Re: Reevaluation Report
Horse Valley Road Horizontal Directional Drill Locations (S2-0157)
Permit No. E50-258
Toboyne Township, Perry County

**HORIZONTAL DIRECTIONAL DRILL ANALYSIS
HORSE VALLEY ROAD CROSSING
PADEP SECTION 105 PERMIT NO. E50-258
PA-PE-0002.0000-RD & PA-PE-0002.0000-RD-16
(SPLP HDD No. S2-0157)**

Figure 1. Original 20-Inch HDD Plan and Profile

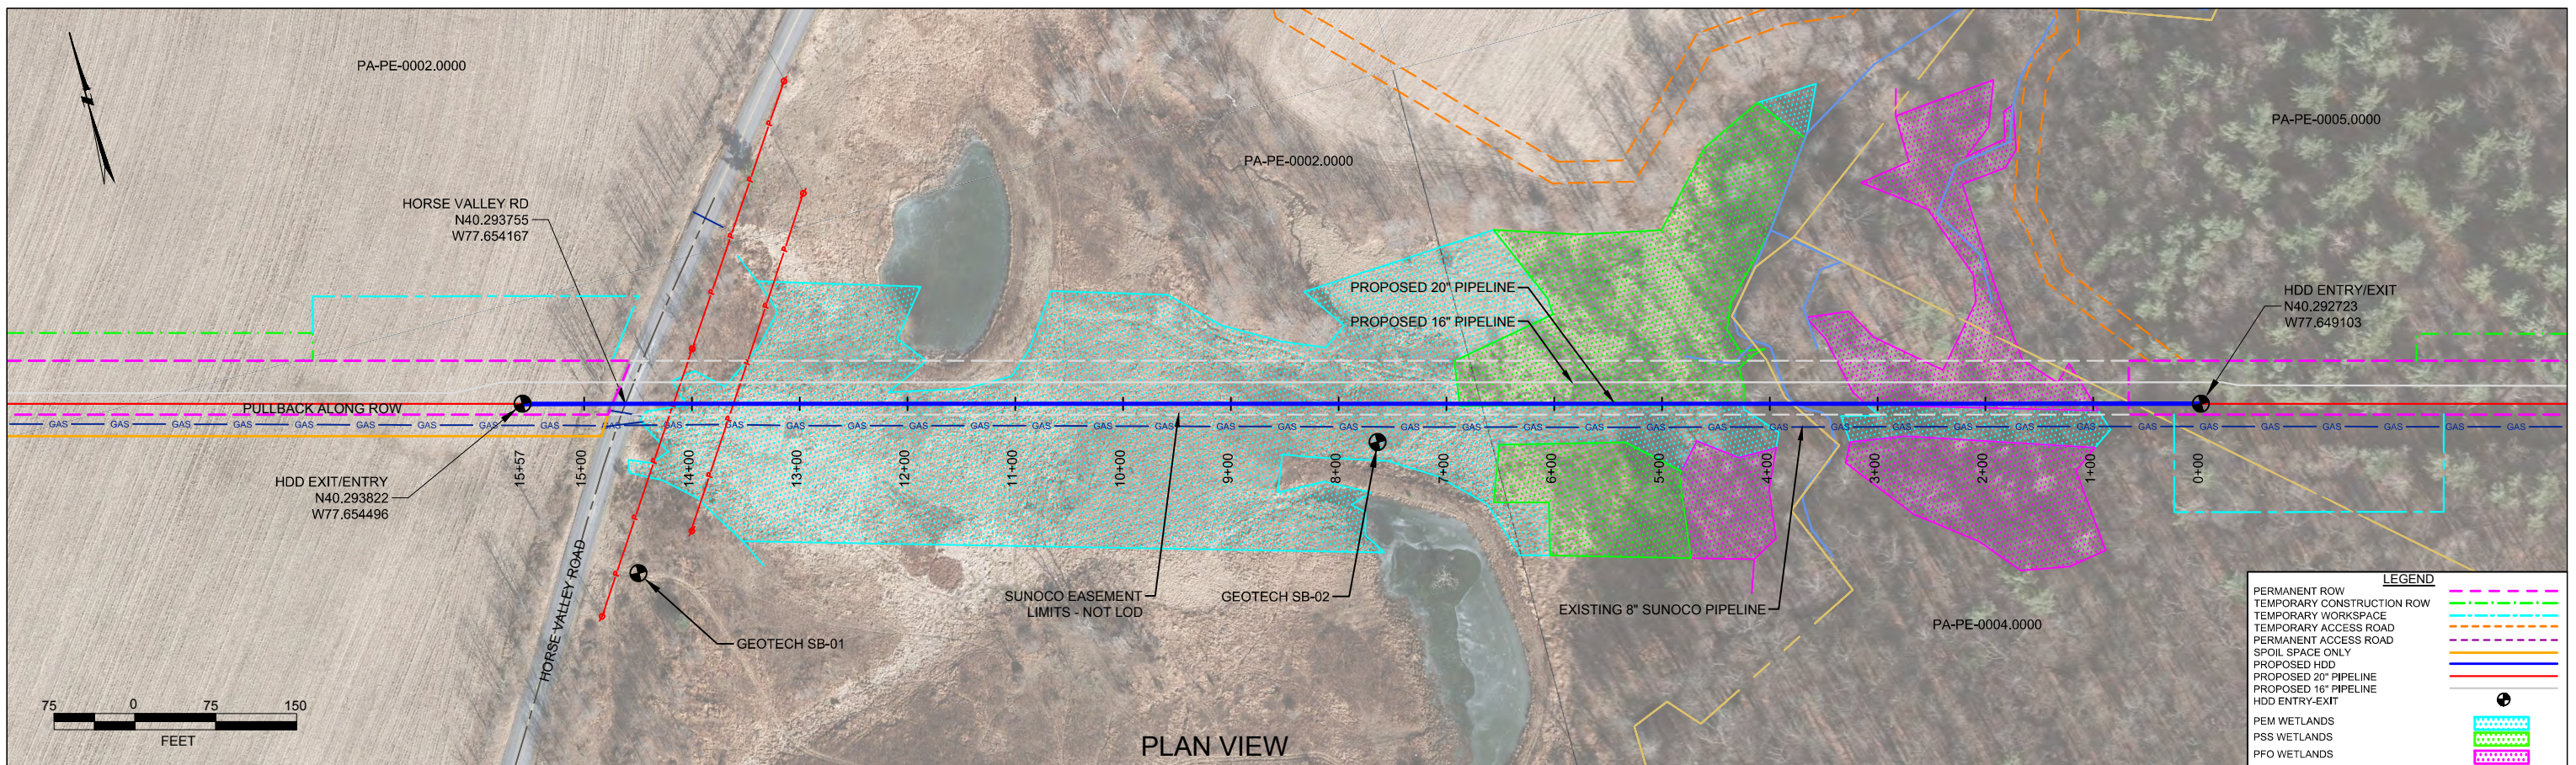
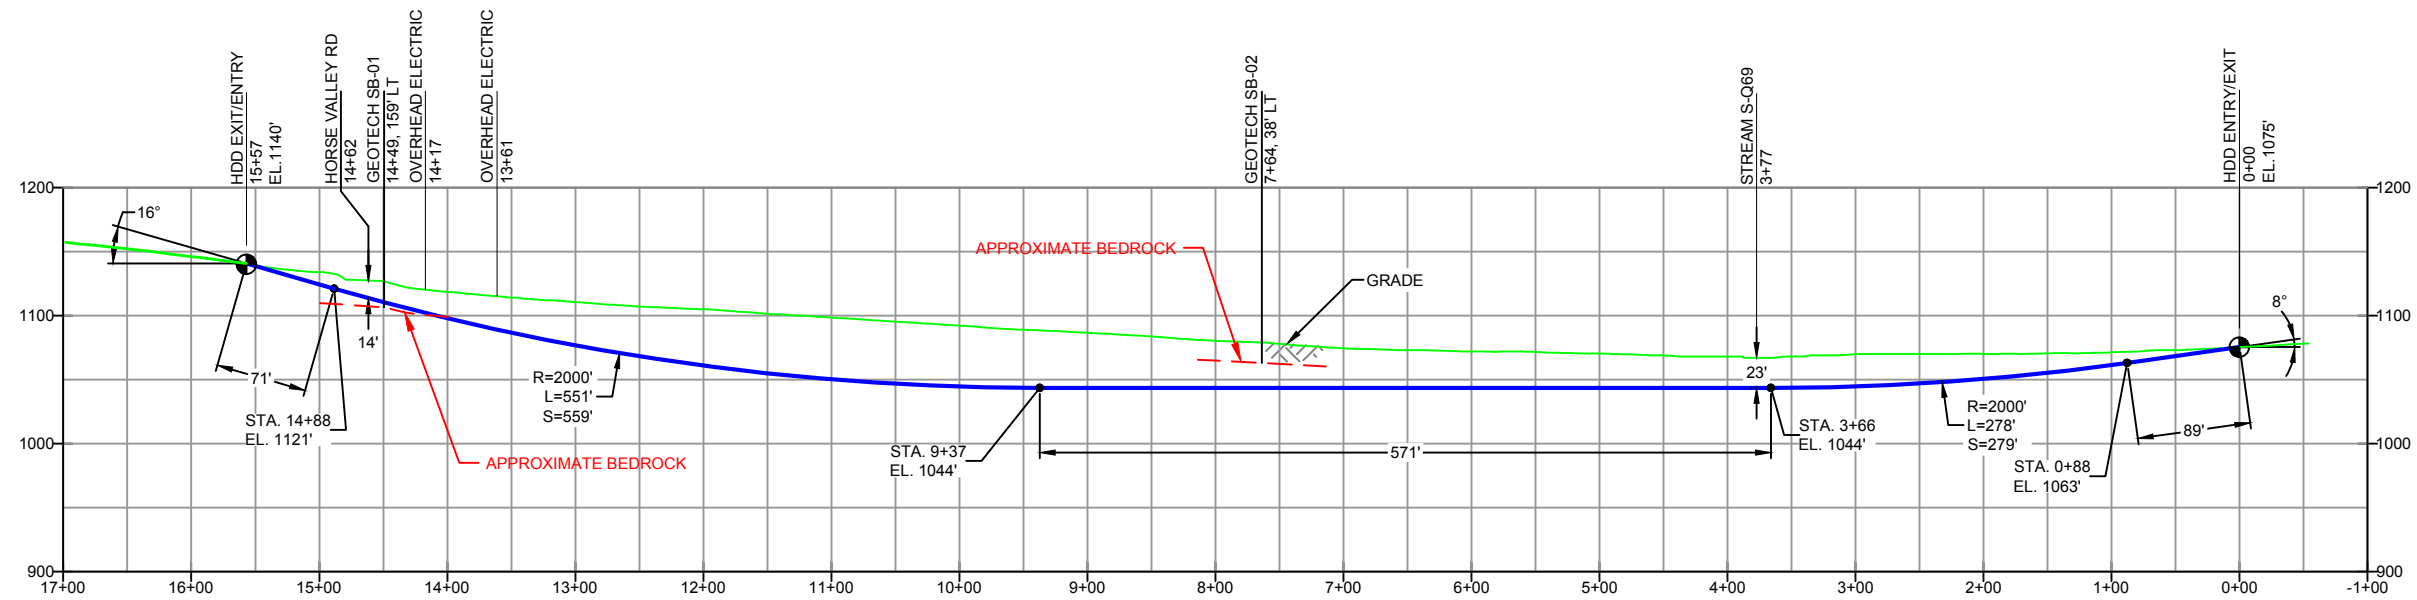
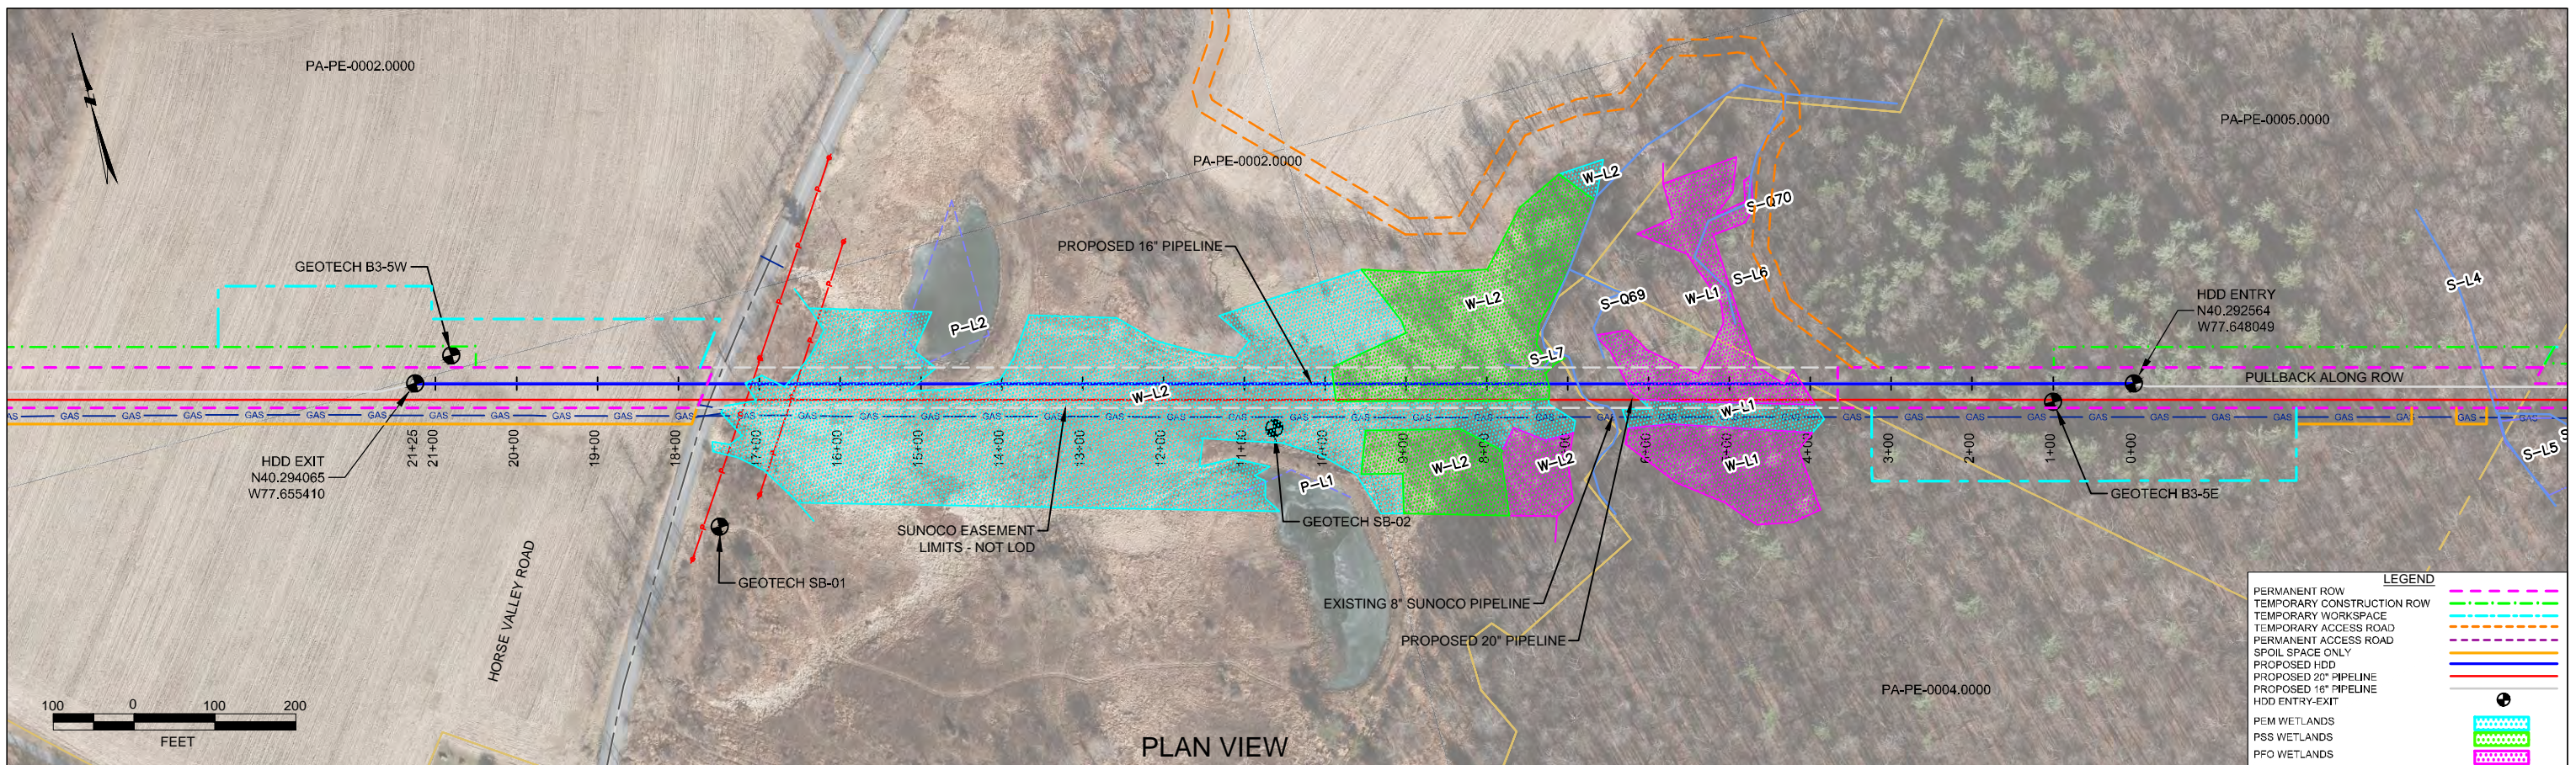
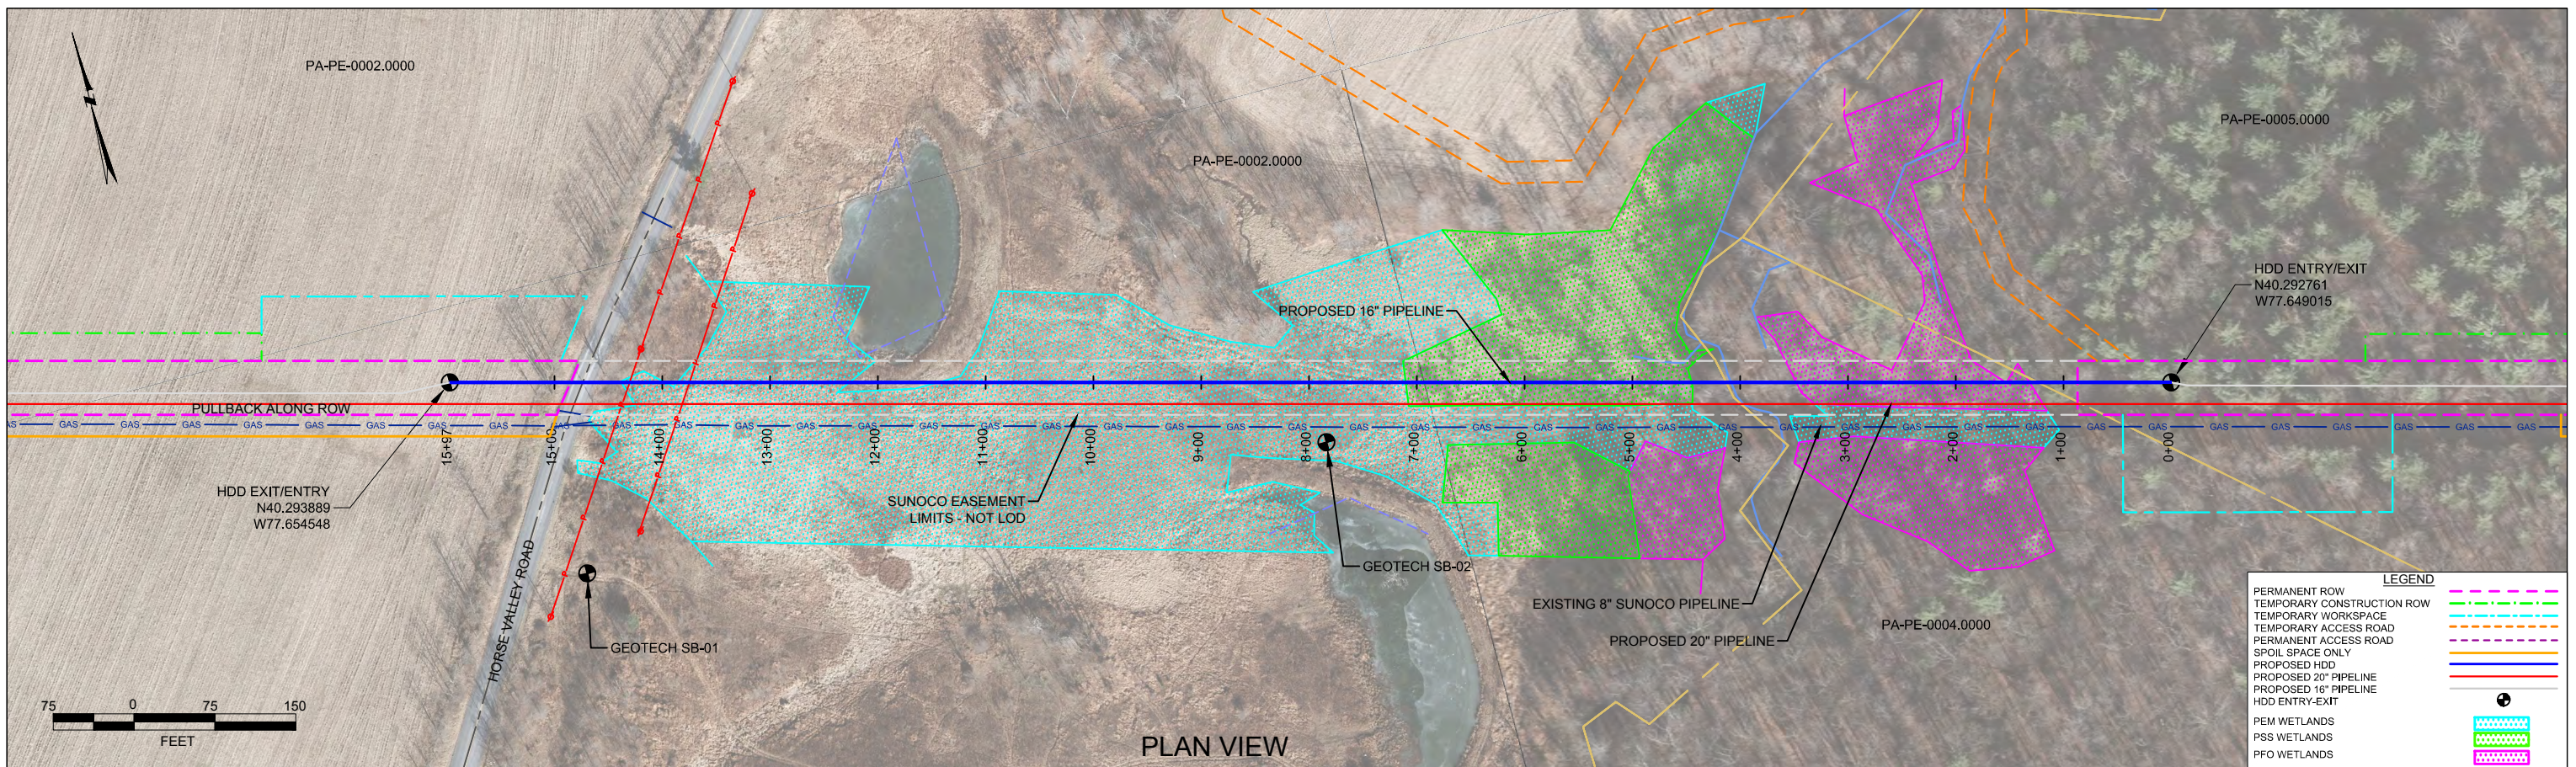
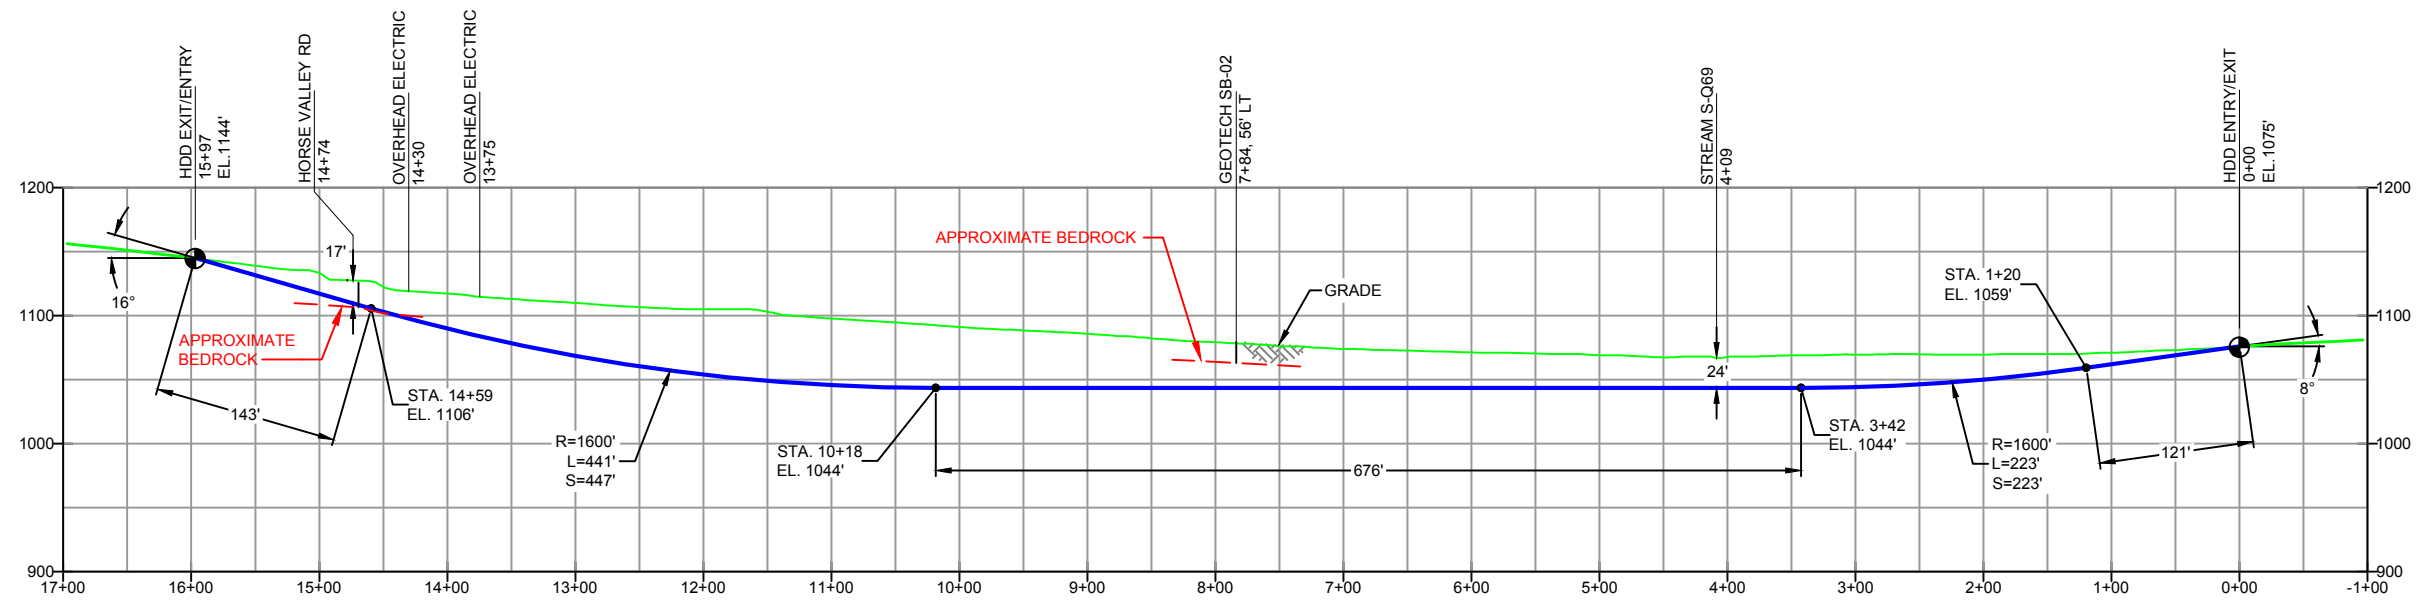
As shown on Figure 2, the redesigned HDD profile for the 20-inch pipeline is 613 ft longer, with a depth of cover below the streams and wetlands increased by 30-59 ft from the permitted design. In addition, the entry/exit angles have been increased allowing for a sharper and quicker descent into more competent rock. As shown on Figure 4 the redesigned HDD profile for the 16-inch pipeline is 528 ft longer, with a depth of cover below the streams and wetlands increased by 20-53 ft and designed for a sharp and quick entry and exit from the horizontal depth.

It is SPLP's intent to modify the original profile design and to pursue a deeper and longer HDD profile. Figure 1 and 3 in Attachment 4 presents the original HDD plan and profiles. Figure 2 and 4 in Attachment 4 present the revised HDD plan and profiles.
